Georgia Department of Transportation
PUBLIC ANNOUNCEMENT
Construction Traffic Staging Modification
for Project CSBRG-0007-00(128)
Chatham County
P.I. No. 0007128

**Figure 2 - Typical Sections
Construction-Phase Traffic Staging
GDOT Project CSBRG-0007-00(128)
Chatham County P.I. No. 0007128
Replacement of the Islands Expressway Bridges
over the Wilmington River**

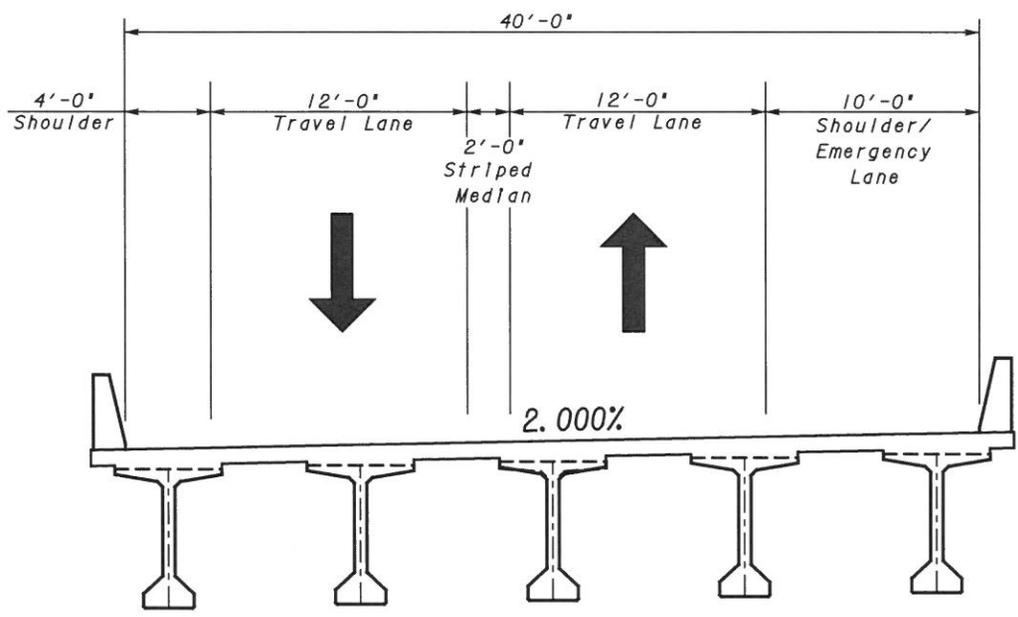
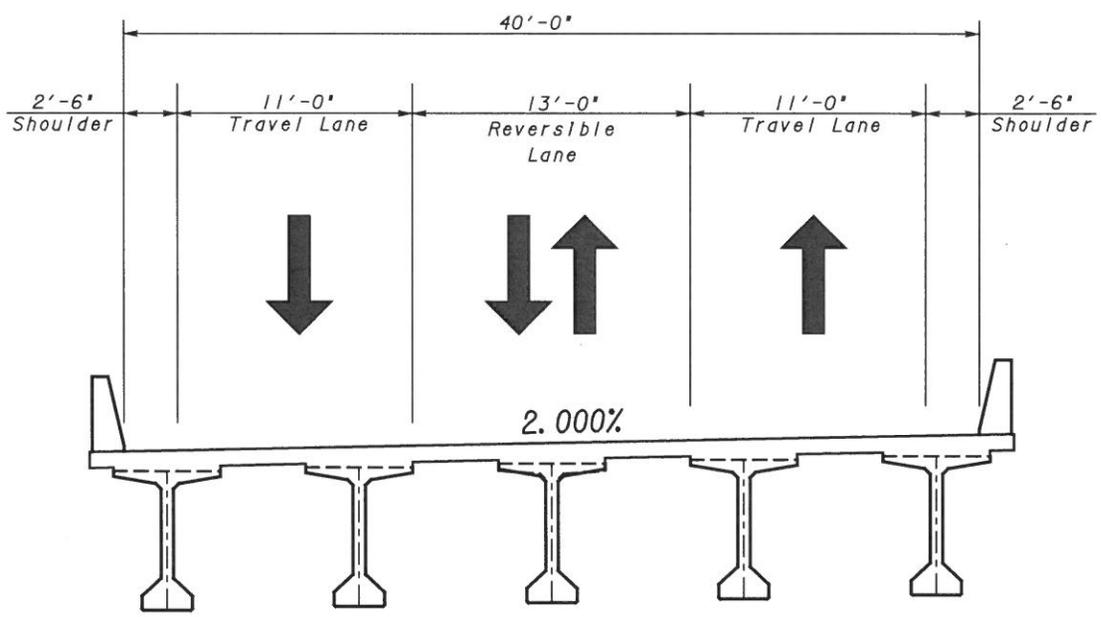
During the second stage of construction (construction of the new eastbound bridge), the proposed project would utilize a two-lane roadway configuration in order to maintain two lanes of traffic (see **Figure 2**). The new westbound bridge would be striped to provide for two 12-foot wide travel lanes (one in each direction) during this stage of construction. The reversible lane configuration is proposed to be removed in order to simplify the construction staging for the new eastbound bridge. The Department has determined that this traffic staging modification is appropriate for this project because the two-lane configuration has been successfully utilized for previous GDOT projects along CR 787/Islands Expressway.
